Subject: Addendum to Geotechnical Investigation Report  
Commercial Building  
37 South Water Street  
Henderson, Nevada

DEI No.: 18-0379

Reference: Geotechnical Investigation Report by DuPont Engineering, Inc. (Report No.: 18-0379, dated September 4, 2018)

**Net Allowable Downward Capacity (Pier Diameter = 3 feet)**

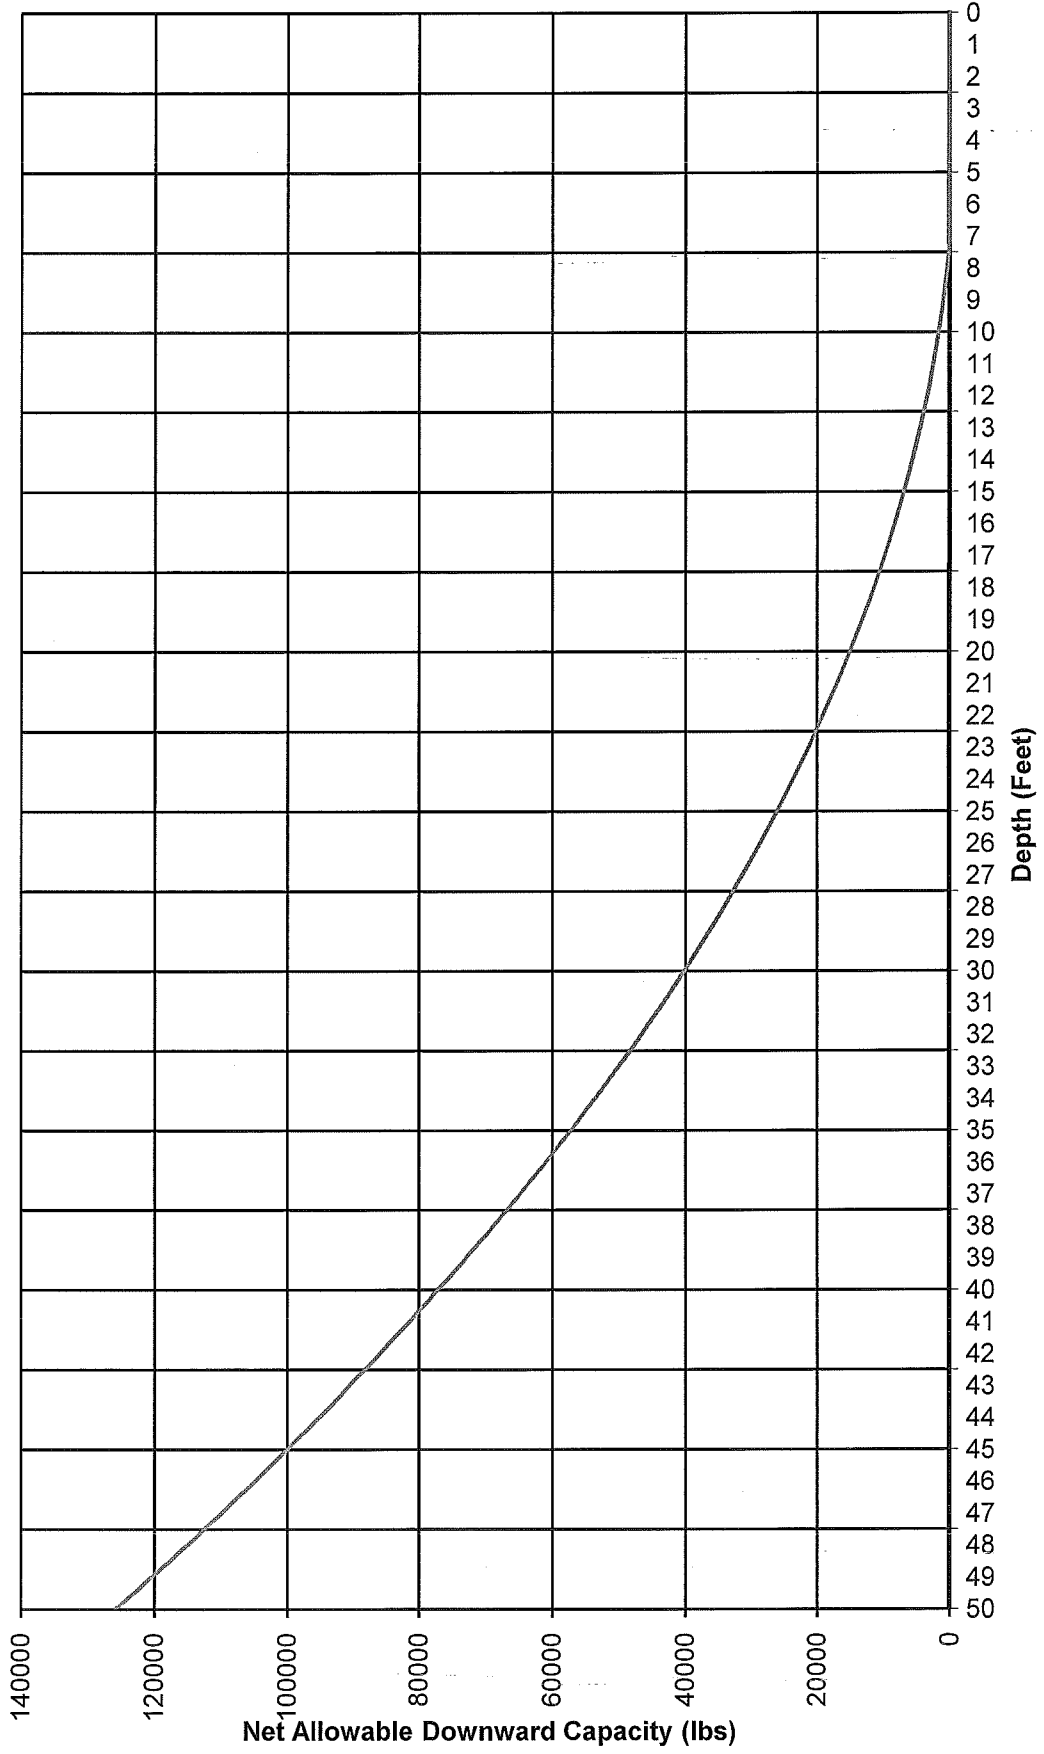
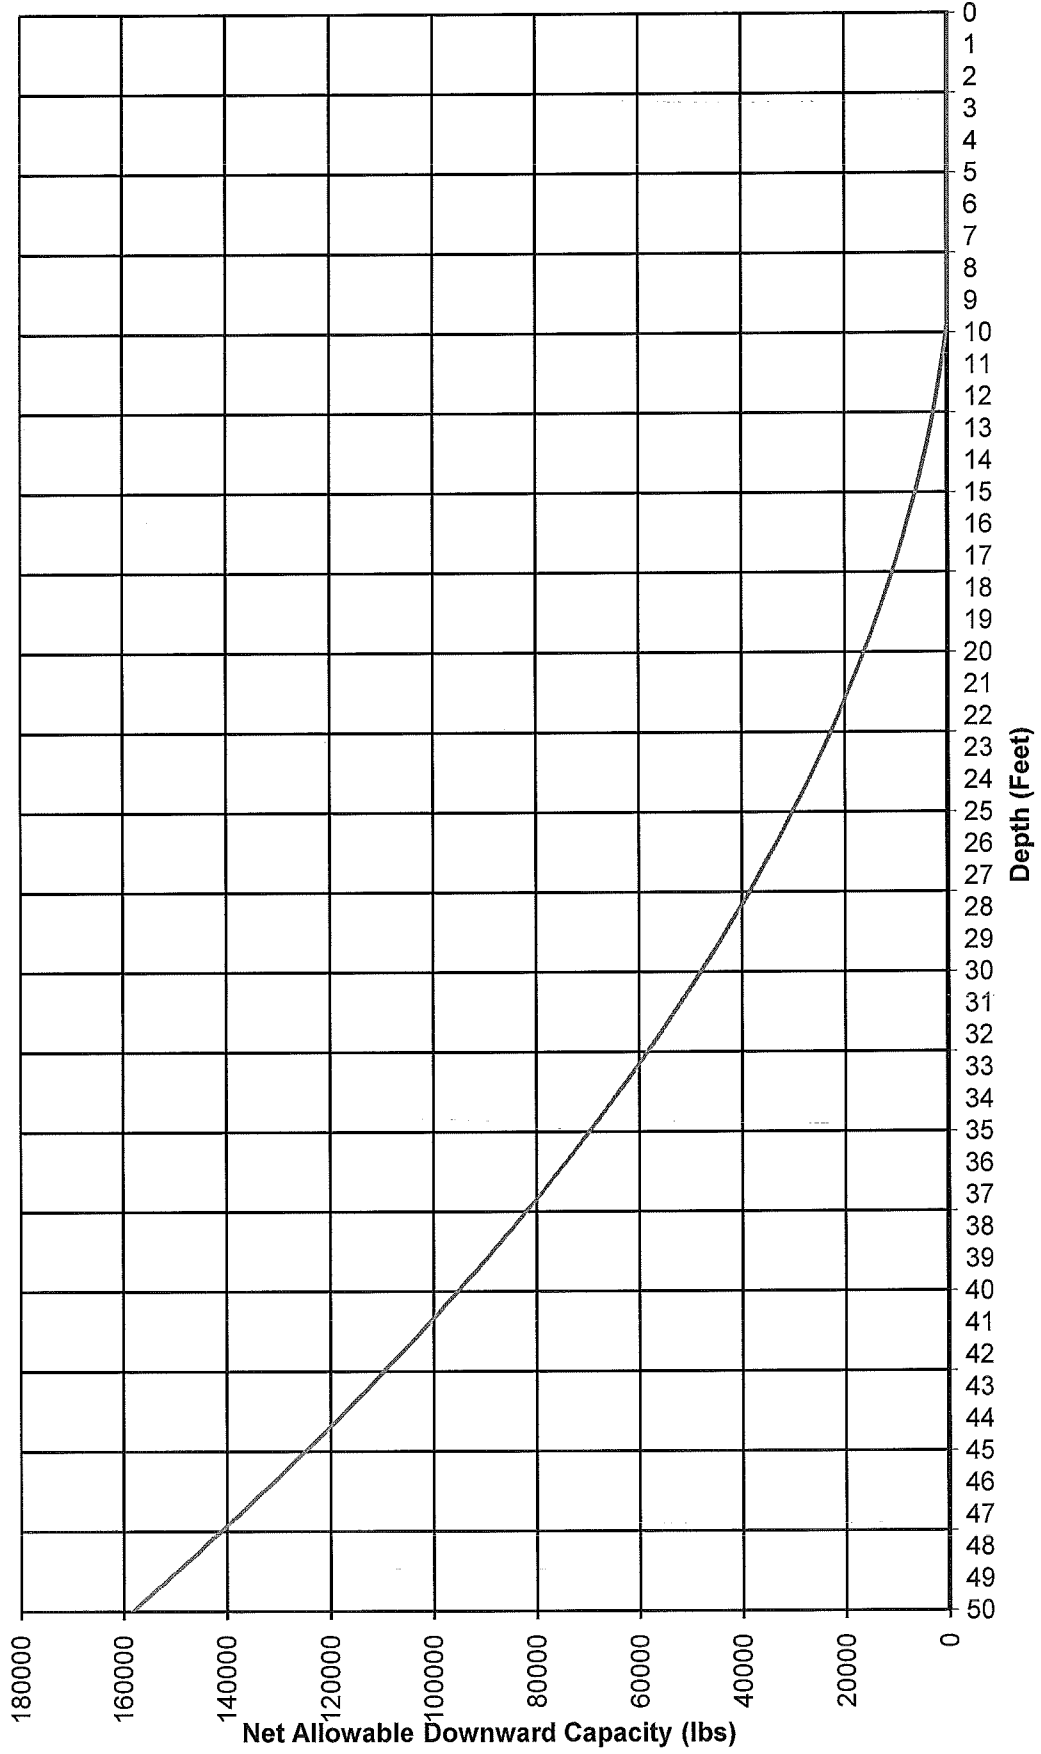
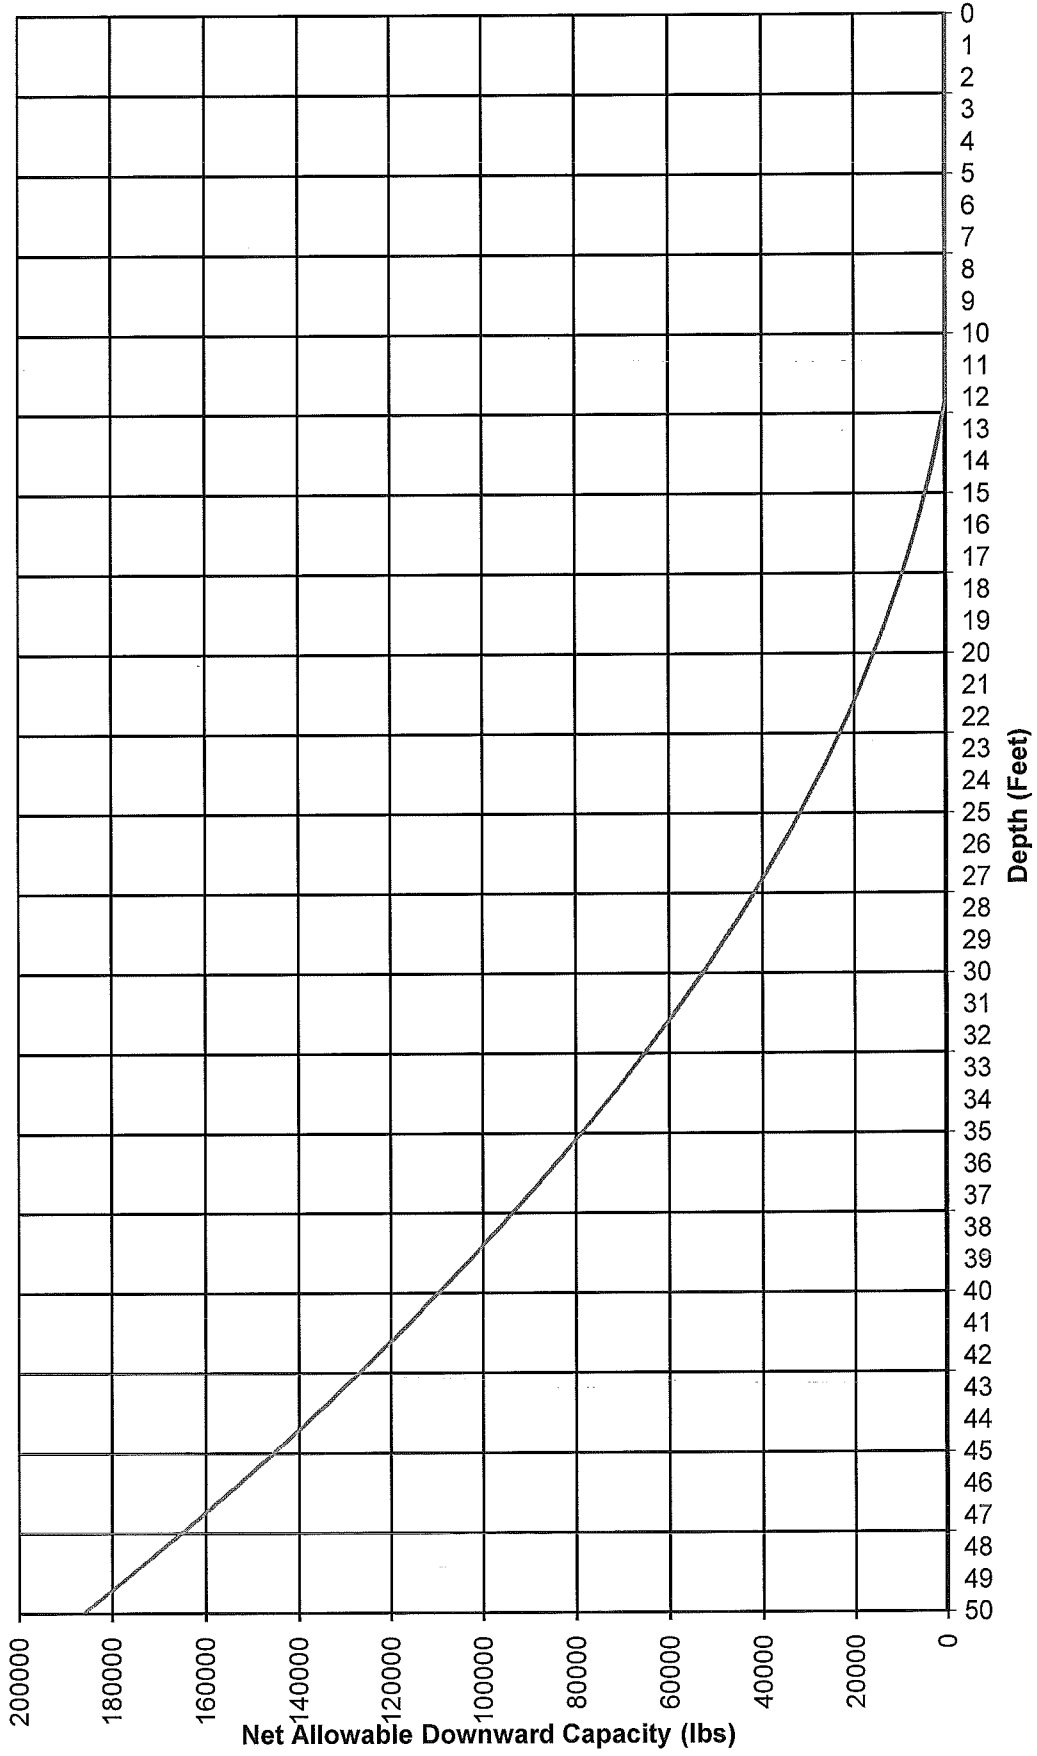
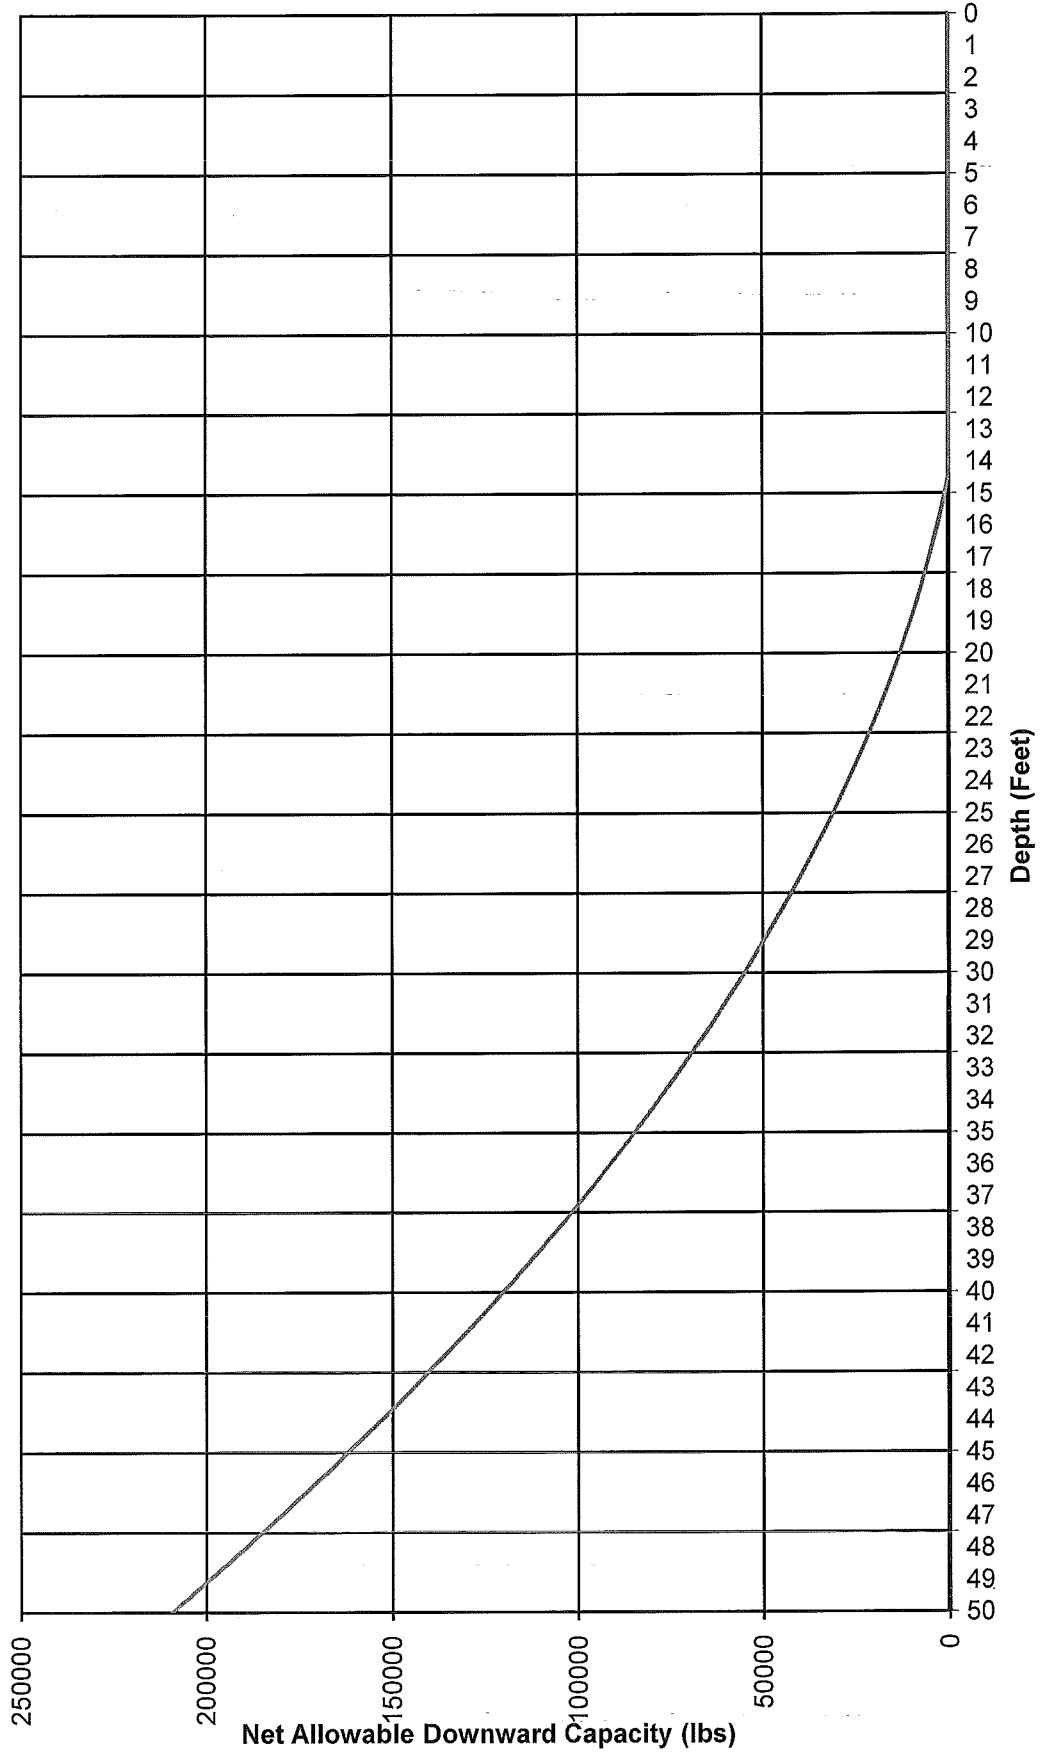
The net allowable downward and uplift capacities (the loads that may safely be placed upon the pier by the tower) have been graphed for several pier diameters and are attached. Factors of safety of 2.5 for downward capacity and 4.5 for Uplift Capacity have been applied.
